### TOWN OF WELLINGTON PLANNING COMMISSION March 1, 2021 6:30 PM

Submitted By: Patty Lundy, Development Coordinator Subject: Meeting minutes of February 1, 2021

Subject: Conditional Use for Human Bean Drive Thru in the C1 Zoning District and Site Plan

SITE PHOTOMETRIC PLAN SCALE: 1" = 10'-0"

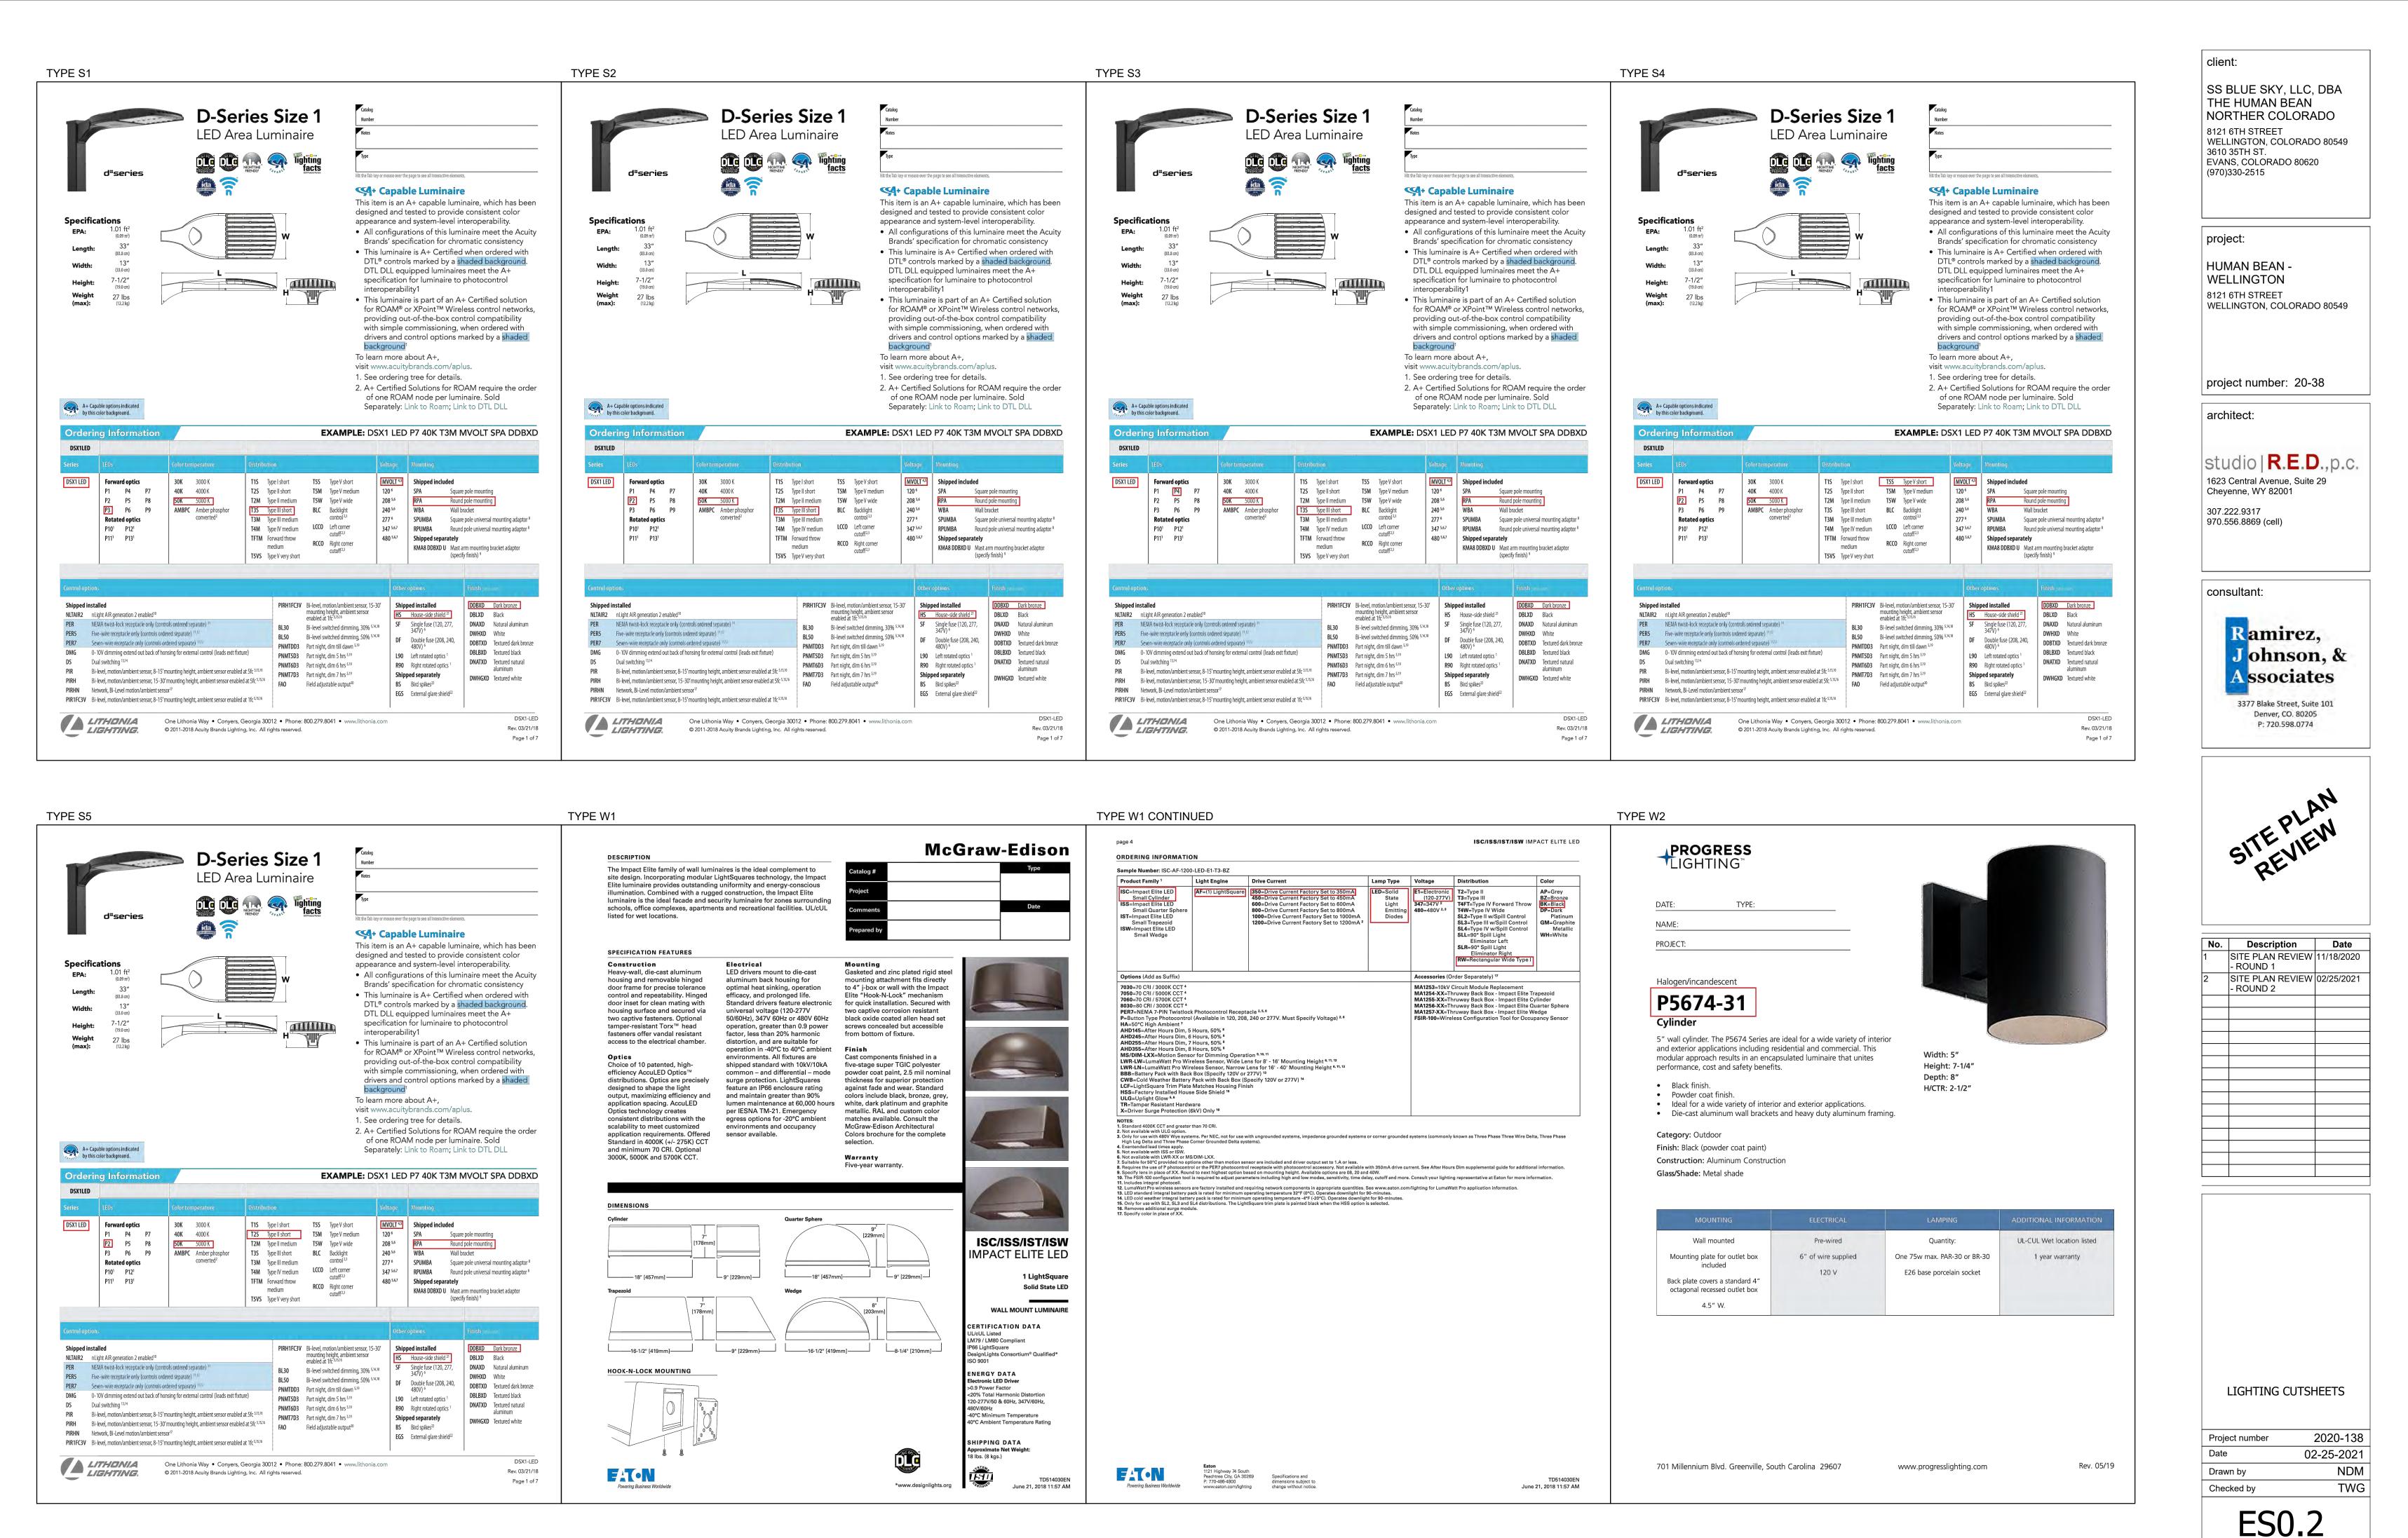
Commissioner Kinney asked to see the lighting plan. Bird showed the lighting plan and where the note is showing the light that would be relocated. Staff is comfortable that the requirements for the site lighting is met but has some concerns about the 6<sup>th</sup> St. corridor. He would like to see the applicant evaluate how to get some additional street lighting to help illuminate the pedestrian path. Kinney would like to see the lighting plan updated.

- Sign plans, including electrical one-line drawings, need to be submitted with the building plans.
- 9. <u>Site Lighting</u>: A photometric plan was provided with the site plans as required. The Town's maximum illumination level at the property line is 0.1 footcandle. There will be a minimal amount of light cast beyond the property line that is generally acceptable along the commercial roadway. The Town has a minimum illumination level of 1.0 footcandle for parking areas and pedestrian paths. The site lighting distribution was updated with the revised site plans and meets the Town's minimum requirements.

Street light relocation shown on the attached sheet ES1.0 - Photometric Site Plan. Street light output is not used in photometric calculations, location is shown for information only.

Pole mounted luminaires have been reselected and relocated to better light pedestrian sidewalk. Lighting along pedestrian sidewalk has been increased. See attached sheet EXO.1 - Photometric Site Plan.
